The Safety Tool Specialists

**PRODUCT OFFERING UPDATES
NOTICE ON 1/4" Square Drive
Torque Wrenches:
30150TW14I or 40200TW14I
March 2024**

New Style

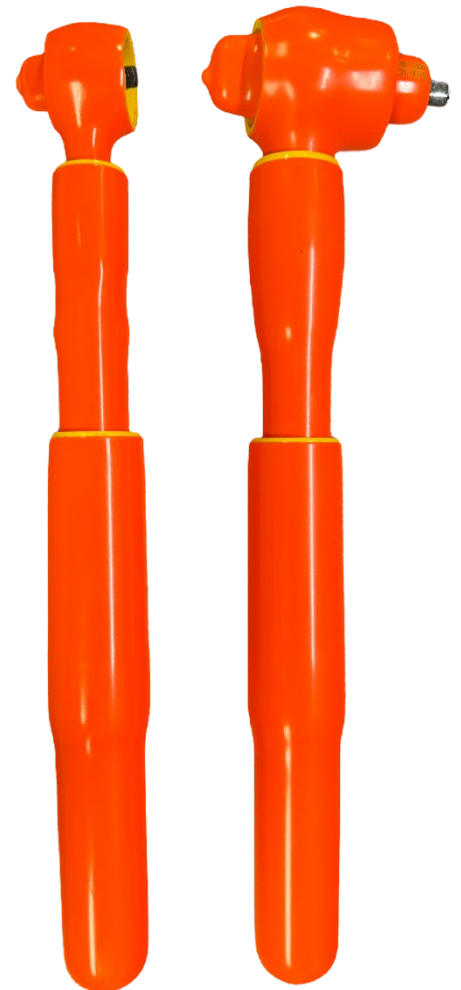
Our new true 1/4" Square Drive torque wrench head for direct connection of sockets.
Exactly right, no adapter required!!

Our new head size features a smaller diameter with direct connection to 1/4" drive sockets so either of these torque wrenches can be used in tighter spaces. **Winner!!**

Old Style with adapter

Head Size: (drive to reversing lever)
New: 1-1/2" Old: 3-1/4" (incl. adapter)
Head Diameter: New: 1-1/4" Old: 1-1/2"

No other torque wrench dimension changes.
No actions required.
